RS-18-102

Byron Station, Units 1 and 2
Renewed Facility Operating License Nos. NPF-37 and NPF-66
NRC Docket Nos. STN 50-454 and STN 50-455

Subject: License Amendment Request for a One-Time Extension to Technical Specification 3.8.1, "AC Sources-Operating," Required Action A.2

Figure 6: Simplified Drawing of a Portion of the Byron Station, Units 1 and 2 Electric Power System with Temporary Alignment Highlighted (For Information Only)

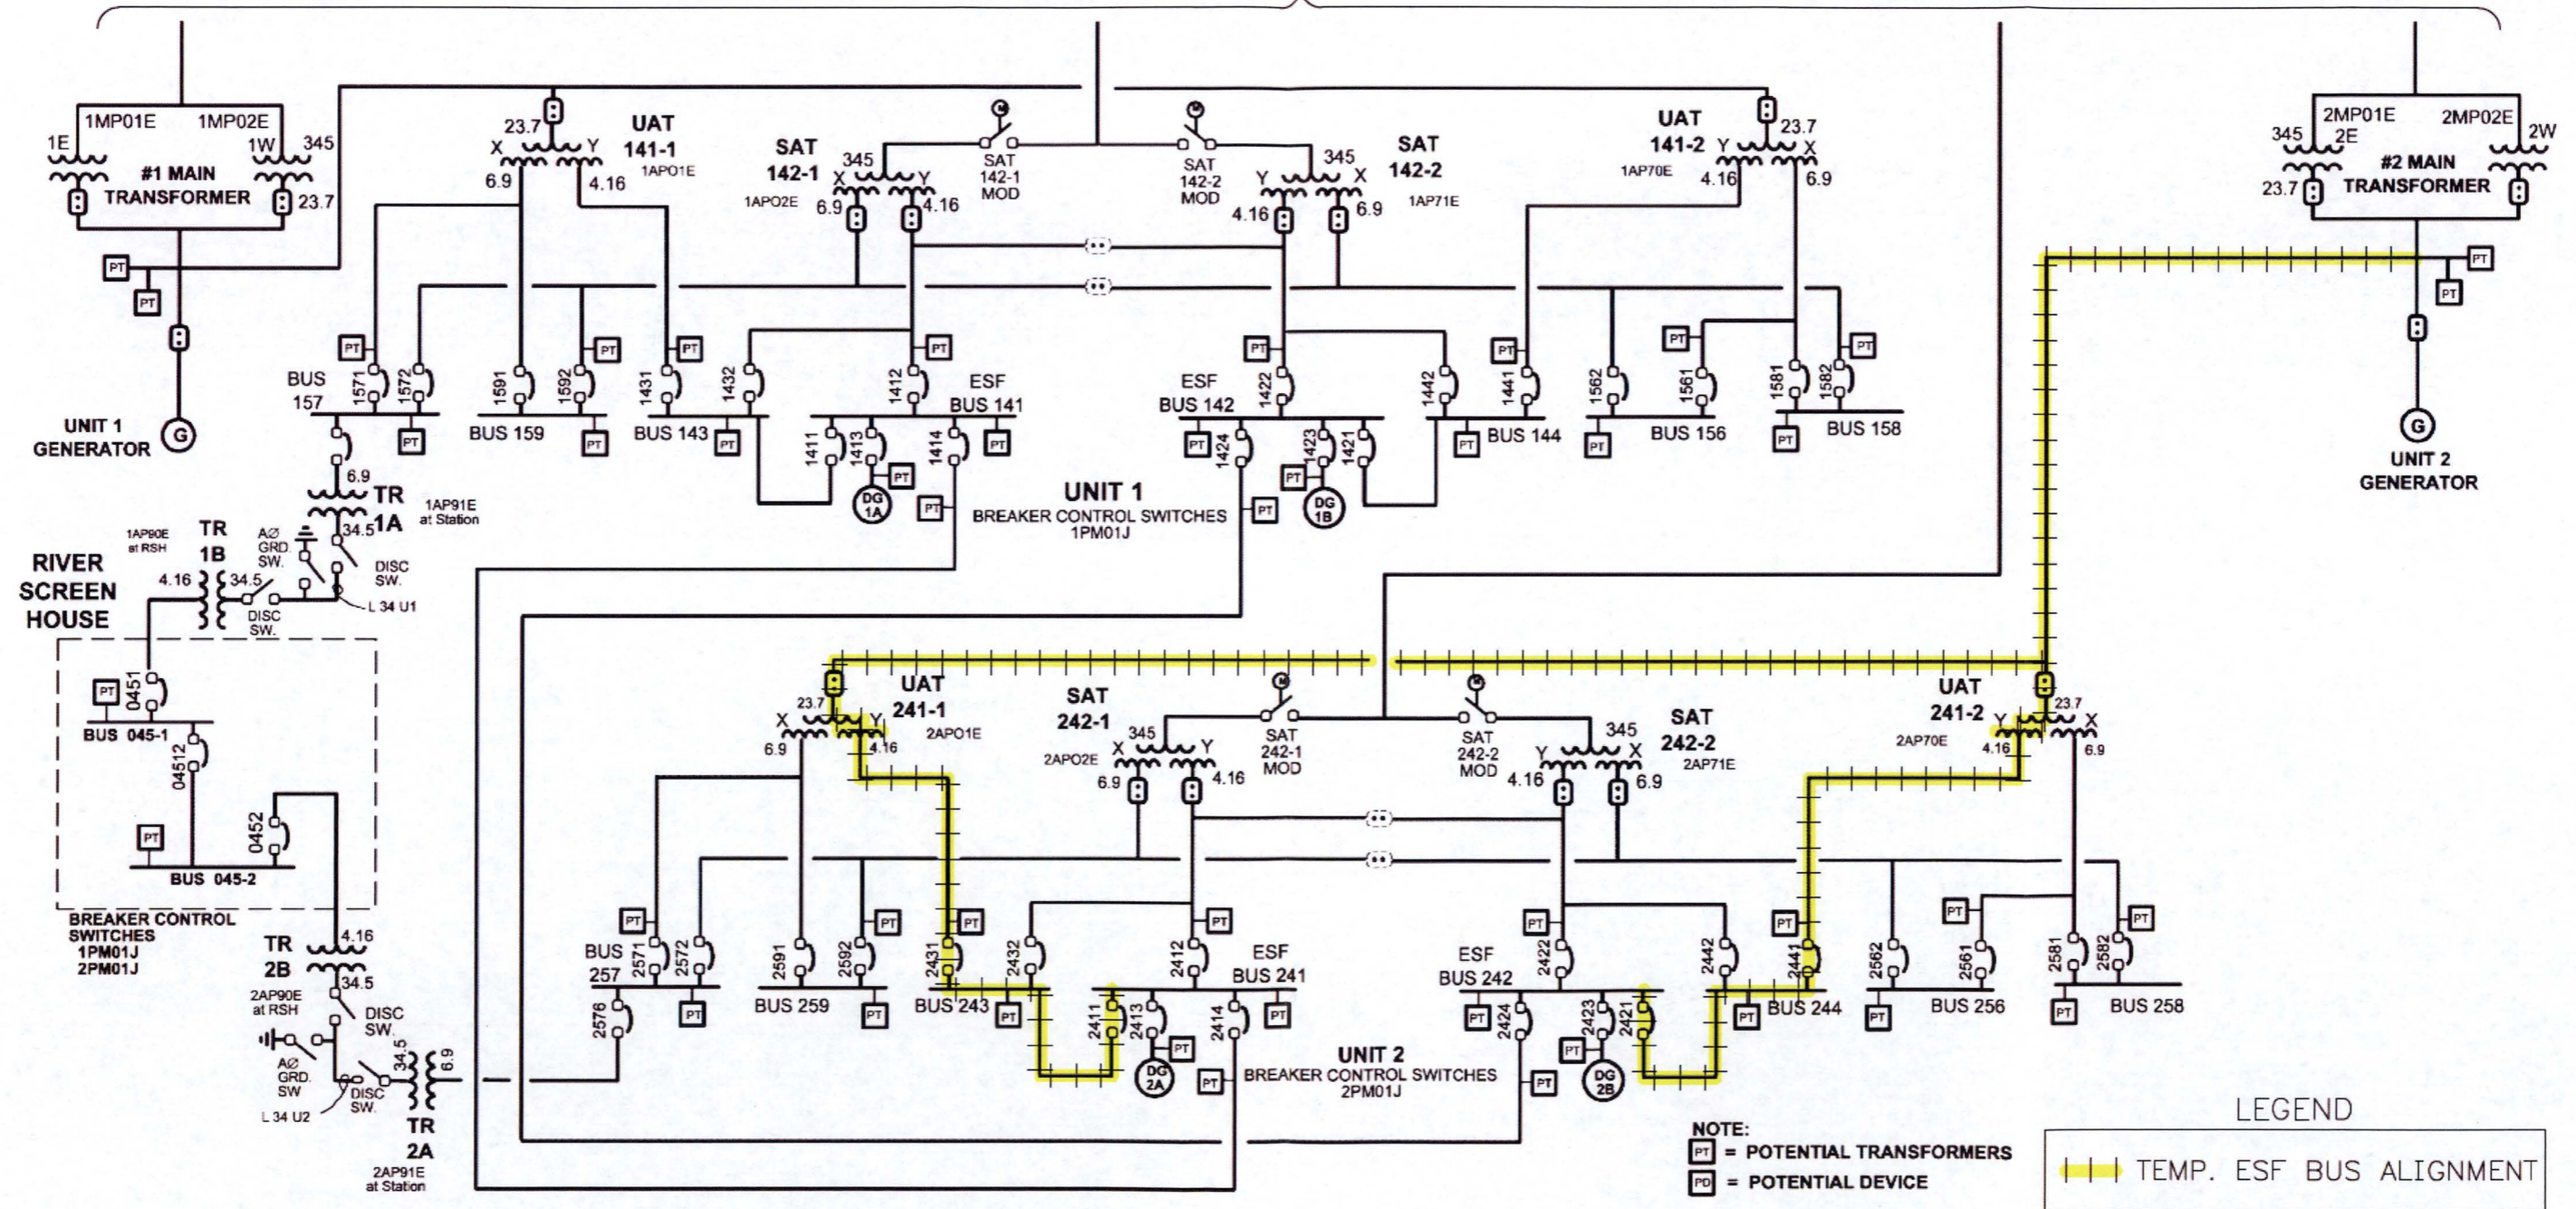
Following an unanticipated failure of SAT 242-1, the EGC intends to implement a modification to restore power to Buses 241 and 242 from Buses 243 and 244 via Breakers 2411 and 2421, respectively. Bus 243 is powered from Unit Auxiliary Transformer (UAT) 241-1 and Bus 244 is powered from UAT 242-2, which receive power from the output of the Unit 2 main generator.

Figure 6 below is a simplified drawing of a portion of the Byron Station AC electric power system including a depiction of the alternate lineup that will be utilized during the requested extended Completion Time. This is the alignment that was assumed in the analysis of plant risk during the extended Completion Time as discussed in Section 4.3 below and Attachment 7 to this request.
